SUBJECT: TECHNICAL REVIEW: GROUNDWATER MONITORING AT AND
NEAR THE PLANNED SALTSTONE DISPOSAL FACILITY
(DOCKET NO. PROJ0734)

Technical Review: Groundwater Monitoring at and Near the Planned Saltstone Disposal Facility

Technical Review: Groundwater Monitoring at and Near the Planned Saltstone Disposal Facility

Figure 3: Groundwater Monitoring Wells in the Z Area and Z Area Cross Section A-A' (from SRNS-TR-2017-00227)

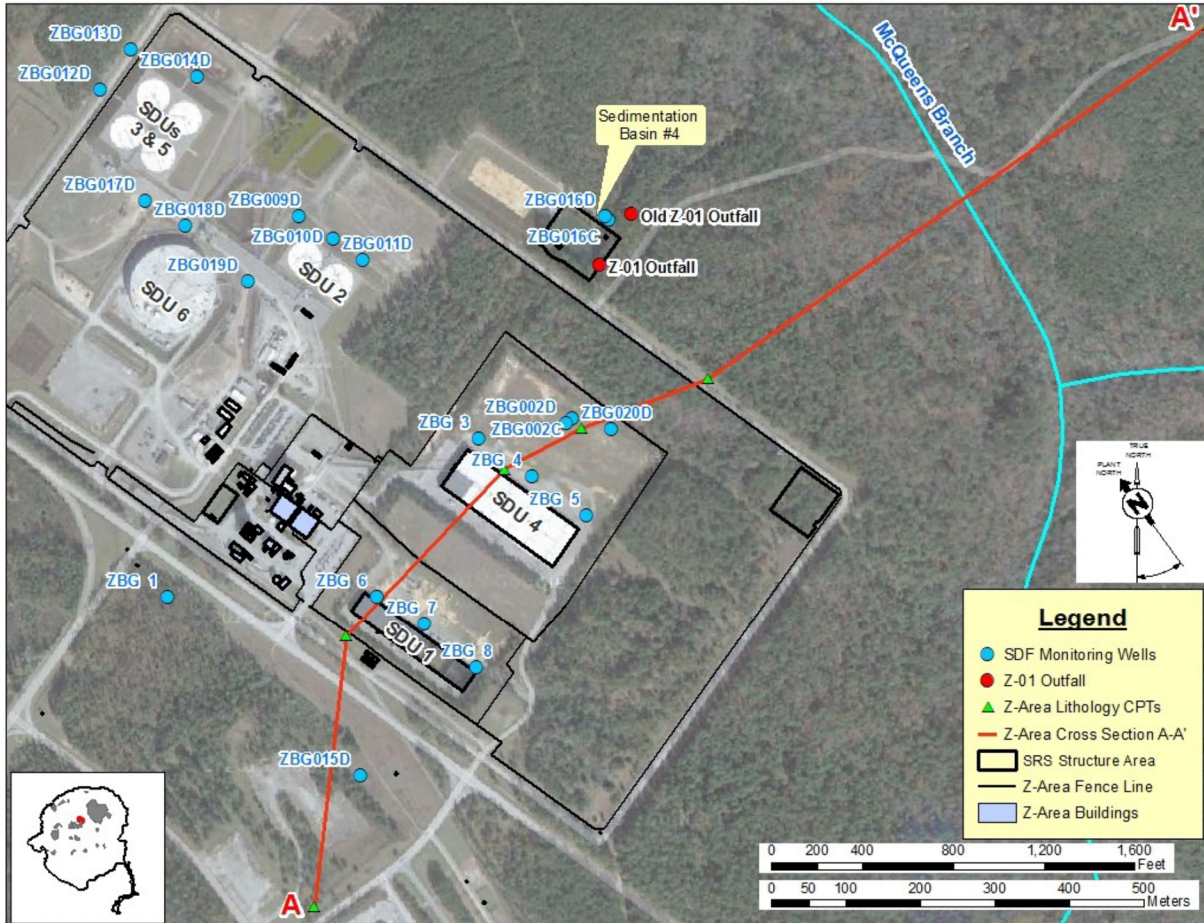
A key aspect of the DOE groundwater monitoring program is the placement of the wells (see Figure 3). For the monitoring wells to provide useful information, they must be located downgradient of the saltstone disposal structures and must be close enough to the saltstone disposal structures to see radionuclides or other indicators that may leach from the saltstone waste form. Similarly, it is important for the wells used to obtain information regarding the natural groundwater composition to be upgradient of the saltstone disposal structures. The groundwater divide on the SDF may complicate the assessment of the well locations, especially because there is some uncertainty in the location of the divide and the location can change with changes to infiltration.

Figure 5: Approximate Extent of the Tc-99 Groundwater Plume and Contours of the Top of TCCZ in Z Area (from SRNS-RP-2015-00902)

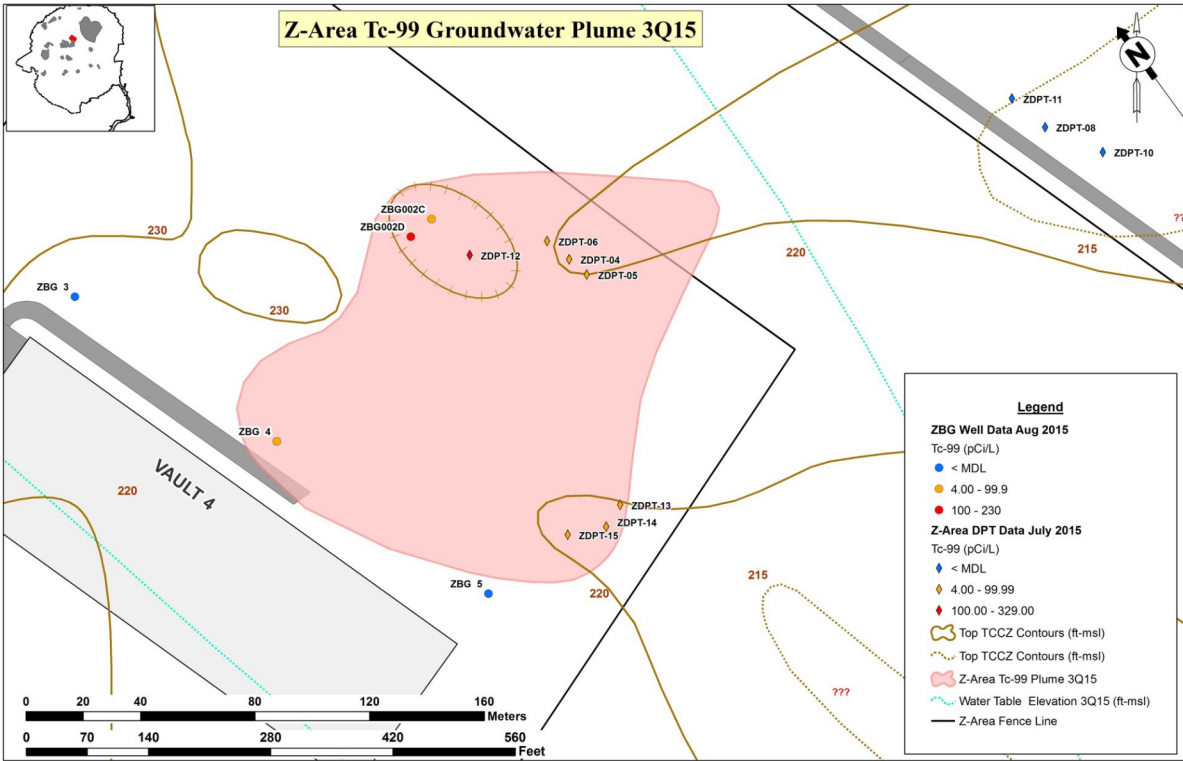
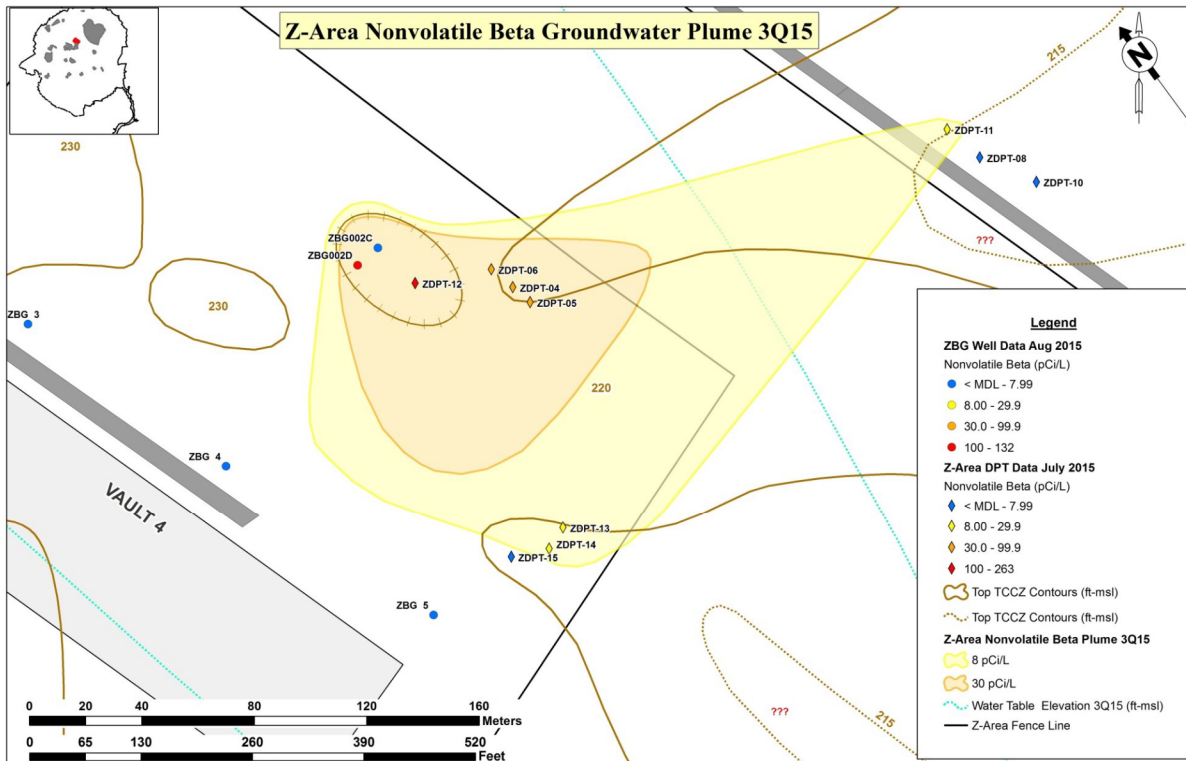
Since 2012, groundwater data has shown an increase in concentration of radionuclides in Well ZBG 2 as discussed in the previous section 'Summary of Current Groundwater Monitoring Results.' Although the elevated nonvolatile gross beta analysis for Well ZBG 2 was originally attributed to naturally-occurring radionuclides (SRNS-TR-2012-00285; Page 5), higher measurements the following years made plain that it could not be solely attributed to naturally-occurring radionuclides. In March of 2013, the nonvolatile gross beta had already exceeded 30 pCi/L at ZBG 2 with sampling result of 68.0 pCi/L. The DOE 2010 Groundwater Monitoring Plan (WRSC-TR-2005-00257, Rev.5) stipulates data reporting and actions in case of sample results exceeding the GWPS. This plan states that, "If the follow-up sampling confirms results above 30 pCi/L for gross beta, a plan for assessing the lateral and vertical extent of the plume will be developed and submitted to SCDHEC within 60 days," and also, "If a GWPS is exceeded, this will be reported to SCDHEC promptly, and the well will be resampled within 30 days. If the exceedance is confirmed, all wells will be sampled for the complete GWPS list (Table 1), and an assessment monitoring plan will be submitted." Subsequently, additional sampling and a resulting Z Area groundwater characterization study documented (SRNS-RP-2015-00902) a plume (see Figures 5 and 6 in this report).

The results of the 2015 Z Area groundwater characterization study provided convincing evidence that the plume has traveled past the boundaries of the Z Area (especially the results of ZDPT 10 and ZDPT 11), and that horizontal transport is much more dominant than vertical

The DOE has not demonstrated that the lateral and vertical extent of the SDS 4 plume is known. For example, it is not clear if the contaminants have reached the McQueens Branch or at what point the water table dips below the TCCZ. Also not clear is why ZDPT 7 and ZDPT 9 were dry when they are at the center of a TCCZ trough as shown in Figure 20 of SRNS-RP-2015-00902 while the higher concentrations have been in ZDPT 11, which is not in the center of the trough as shown in Figures 21 and 23 of the same report.

Figure 7: 2017 Nonvolatile Gross Beta Groundwater Plume from Figure 8 in SRNS-TR-2017-00387 Shown as Dashed Orange Line

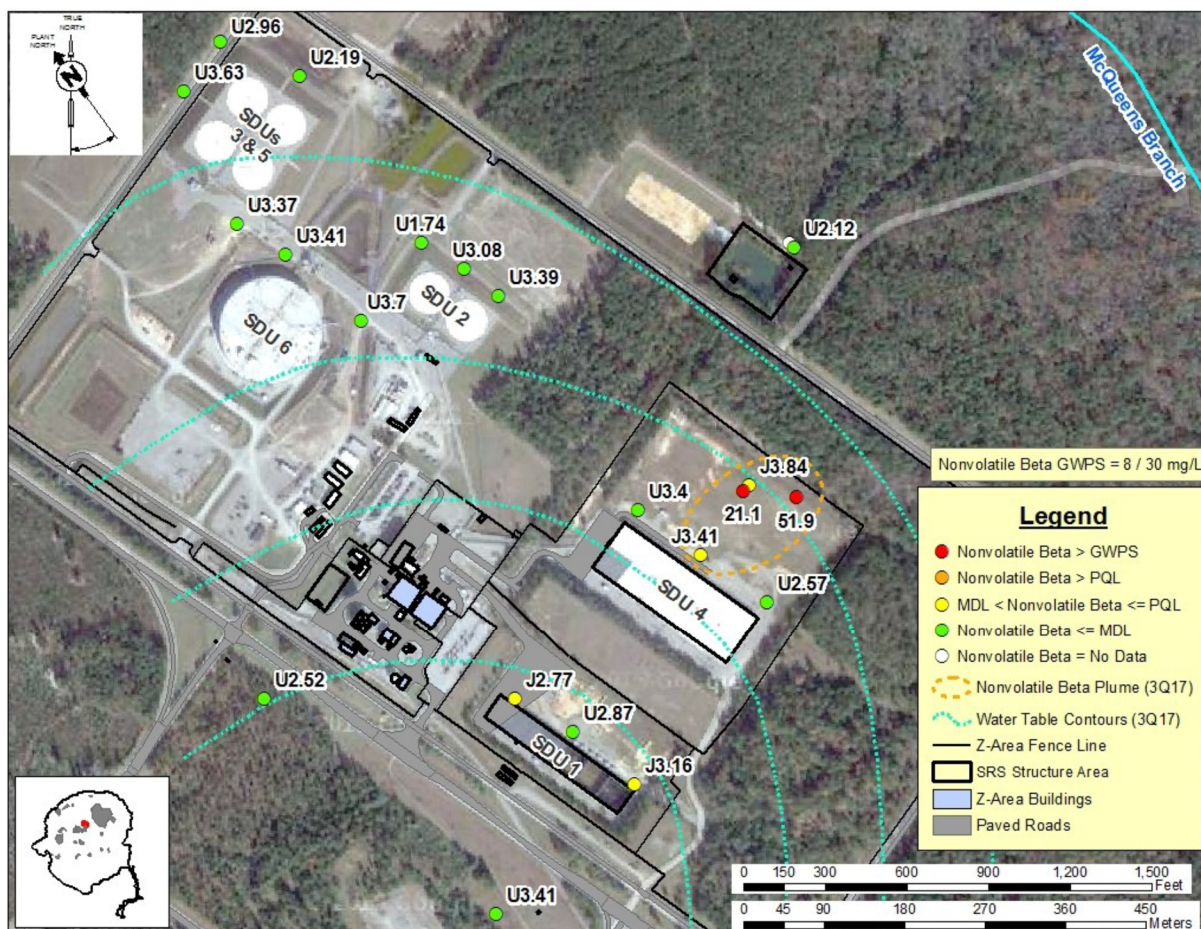
The Z Area groundwater report from 2016 and 2017 (SRNS-TR-2016-00312 and SRNS-TR-2017-00387, respectively) no longer include the results from the 2015 Z Area groundwater characterization study when showing the extent of the plume (see Figure 7 below). Figures 8 and 9 in the 2017 Z Area Groundwater Report show a dashed line representing the extent of the nonvolatile gross beta plume and Tc-99 plume, respectively. Both plumes are considerably smaller than the plumes showed in the 2015 Z Area Groundwater Report (i.e., Figure 6 for nonvolatile gross beta and Figure 8 for Tc-99 in SRNS-TR-2015-00300). The representations of

the 2016 and 2017 plumes have been shortened to the east and the south. The DOE gave no explanation for these changes. No UTRA-UAZ data on nonvolatile gross beta and Tc-99 exists which would allow a delineation of the plumes' boundaries to the north.

Figure 7 from the 2017 Z Area Groundwater Report shows peak concentration values for Well ZBG 2 and Well ZBG 2D having occurred back in 2015. As suggested by the DOE, this may indicate that the peak of the plume has moved on. The NRC staff is interested in knowing where the peak of the plume is currently and in what direction it is heading because that knowledge would both provide information on flow and radionuclide transport in the Z Area and allow a better evaluation of the potential safety concerns emanating from the plume. New DPT samples and/or new monitoring wells would be required to follow the peak of the plume.

In summary, the NRC staff is interested in knowing: (1) the source of the current SDS 4 plume (e.g., was it one single event near SDS 4 Cell G in 1997 or has the plume been generated by SDS 4 releasing contaminants due to a series of precipitation events over last 20 years); (2) the lateral and vertical extent of the plume; and (3) predictions of the future development of the plume (i.e., concentrations over time for different locations).

Figure 8(a)-(d): UTRA-UAZ Water Thickness (ft) for the Years 2003 to 2017 (Data from Z Area Groundwater Monitoring Reports from 2003 through 2017)

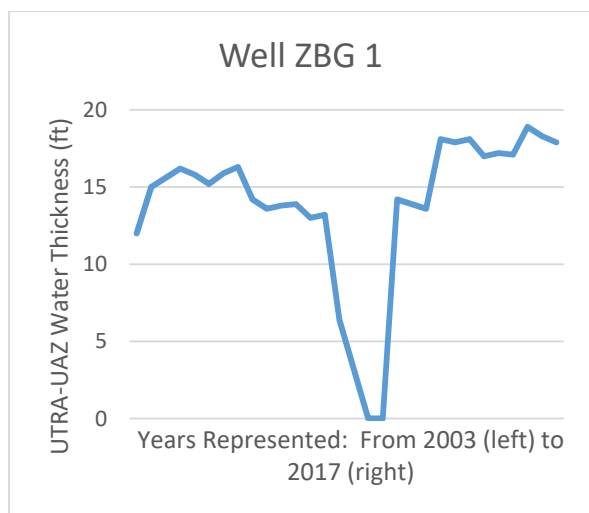
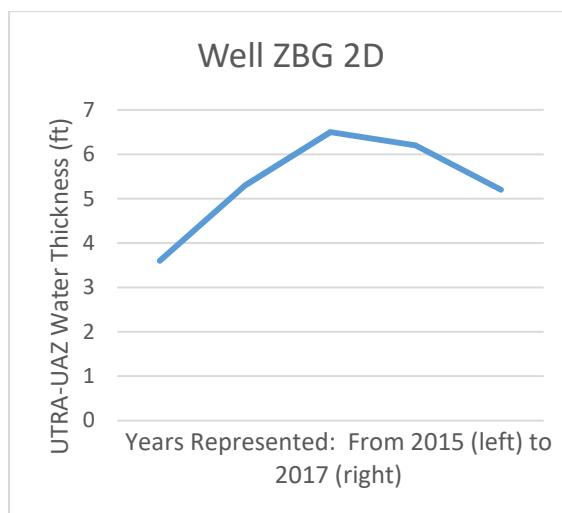
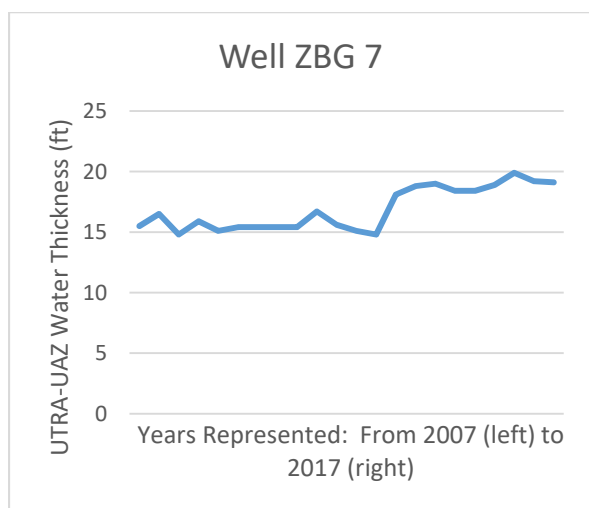
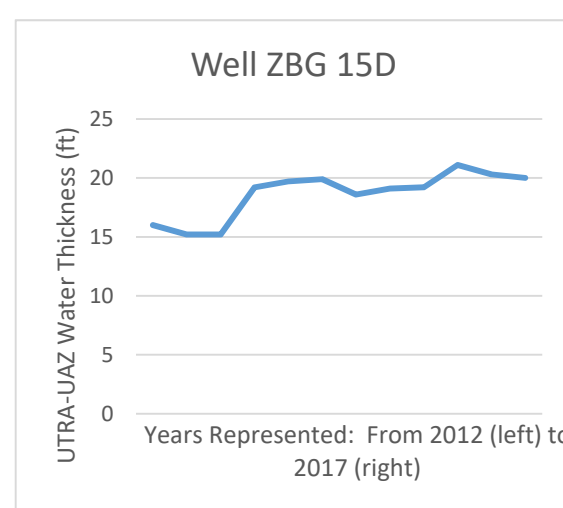
During the NRC February 2015 SDF OOV, as documented in the OOV Report (ADAMS Accession No. ML15041A562), the NRC staff questioned the DOE assumption that contamination was not present in the other locations besides the SDS 4 area and pointed out that there were very few wells screened above the TCCZ in other locations. In response, the DOE noted that in DPT samples located downgradient of SDS 4 and taken from above the TCCZ did not show elevated nitrate. However, other locations besides the SDS 4 area, such as the groundwater monitoring wells near SDS 2, SDS 3, SDS 4, and SDS 5, are only located in the UTRA-LAZ. The UTRA-UAZ below SDS 4 appears not to be saturated at least part of the time since sampling at ZDPT 1, ZDPT 2, and ZDPT 3 came up dry in September of 2014 (SRNS-RP-2014-01214). It is interesting to note that despite the partial or full-time unsaturated condition of the UTRA-UAZ near SDS 4, the contaminants from the unintentional release contaminated the UTRA-UAZ and appeared in the samples from Well ZBG 2 before they appeared in samples from the UTRA-LAZ below SDS 4. If the UTRA-UAZ is saturated and became contaminated near SDS 2, SDS 3, and SDS 5, it is unknown how long the current groundwater monitoring wells in the UTRA-LAZ would take to detect the contaminants in the UTRA-UAZ. For this reason, groundwater monitoring wells should be located in both aquifer zones when monitoring a disposal structure. Depending on the conceptual model of flow, the wells for UTRA-UAZ and for UTRA-LAZ could either be a nested monitoring well or separated in location.

It is possible that it would not be cost effective to install a groundwater monitoring well in both the UTRA-UAZ and the UTRA-LAZ if the UTRA-UAZ is dry near the locations of interest. However, the data that have been collected up to this point indicate that the UTRA-UAZ is saturated for most of the time at many locations. Figure FFT-1.3 from SRR-CWDA-2016-00004 shows the water levels in ZBG 2. Between 1987 and 2014, a total of nine samples were taken when water levels within ZBG 2 were below that of the top of TCCZ coinciding with two periods of relatively low rainfall and indicating that the UTRA-UAZ was dry. However, for the rest of that time period the UTRA-UAZ contained water. Figures 8(a) through (d) also show water thicknesses within the UTRA-UAZ for ZBG 1, ZBG 2D, ZBG 7, and ZBG 15D. Only the background well ZBG 1 had one year (2011) in which the UTRA-UAZ was dry, and the data for 2010 is missing with regard to Well ZBG 7 which is representative of the area near SDS 1. Wells ZBG 6 and ZBG 8 had similar UTRA-UAZ water thicknesses as in Well ZBG 7.

- Based on the information described in this TRR, the NRC staff determined that the number of groundwater monitoring wells in the UTRA-UAZ is not adequate. Although contaminants from saltstone would first appear in the UTRA-UAZ, groundwater monitoring wells located near SDS 2, SDS 3, SDS 4, and SDS 5 are only located in the UTRA-LAZ. Due to the findings in SRNS-RP-2015-00902 and given the hydrogeological

influence of the TCCZ, groundwater monitoring wells near saltstone disposal structures should be located in both the UTRA-UAZ and the UTRA-LAZ.
